Title: Advisory Committee on Reactor Safeguards
ESBWR Design Certification Subcommittee

Date: Tuesday, October 2, 2007

SUB-COMMITTEE ON ESBWR DESIGN CERTIFICATION

Isolation Condenser - Standby

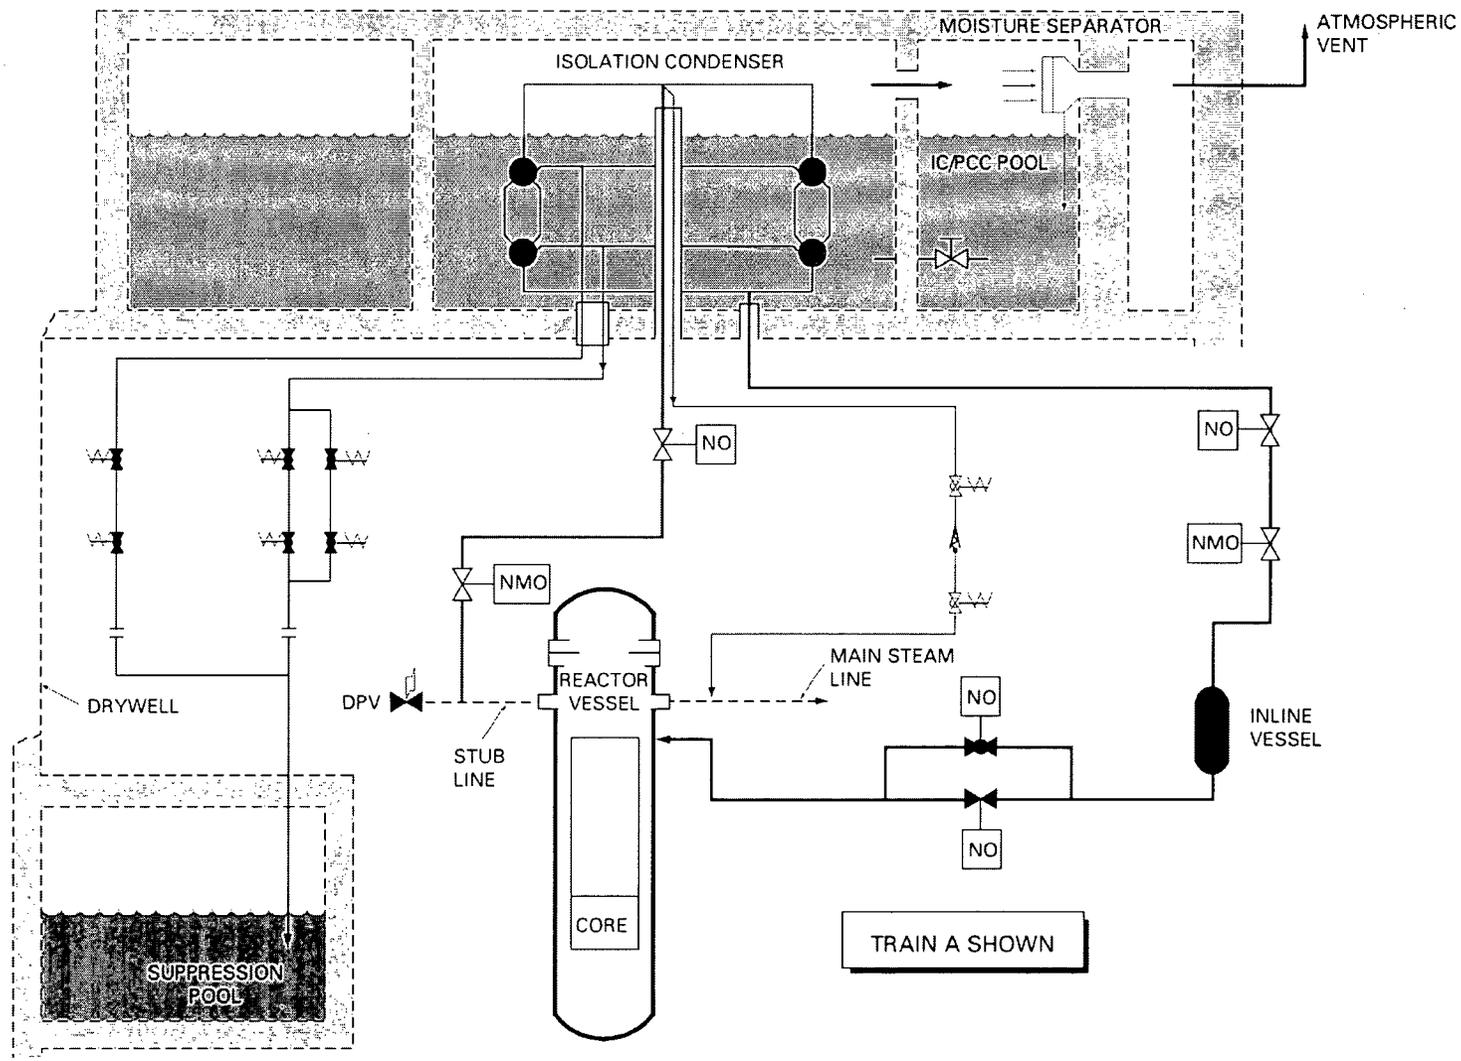
11 CHAIR CORRADINI: So, that leads me, I
12 guess, to my next question, which is, I was going to
13 ask how different are these isolation condensers. So,
14 the previous ones were horizontal.

20 CHAIR CORRADINI: Okay, so -- so then, I
21 guess back to my question, which is, the change in
22 design was initiated because of performance of those?
23 Why vertical now versus horizontal? I'm trying to
24 understand the design change from the isolation
25 condenser design that you previously had.

1 MR. BEARD: I don't know the full answer
2 to that. I think part of it is we wanted to get the
3 72 hour capability. The other ones, I believe, are
4 only about 30 minute capability for water they have
5 stored in a head tank, as well as what's in the shell
6 itself.

PCCS Schematic

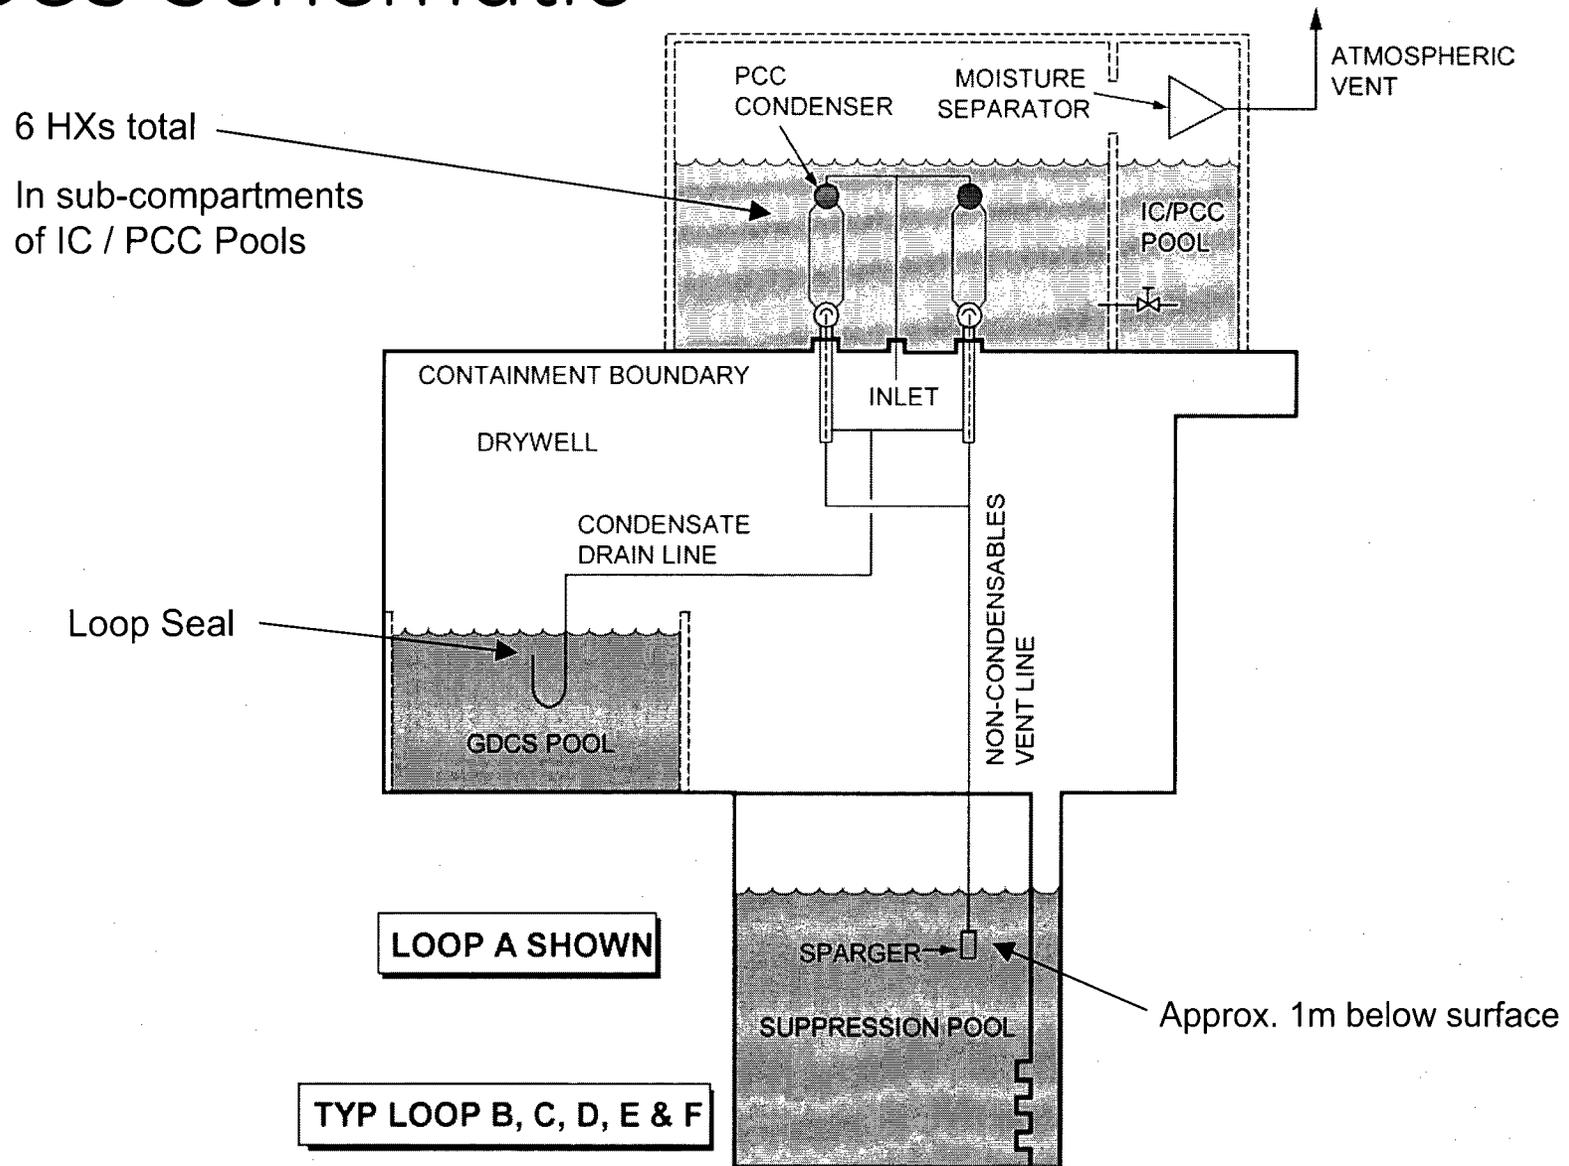
15 CHAIR CORRADINI: Okay. So then, the
16 explanation is?

17 MR. BEARD: The explanation is, all the
18 condensing is being done up in tubes here, non-
19 condensable gas is here and not affecting my --
20 capability, because they are located down in that
21 lower plenum.
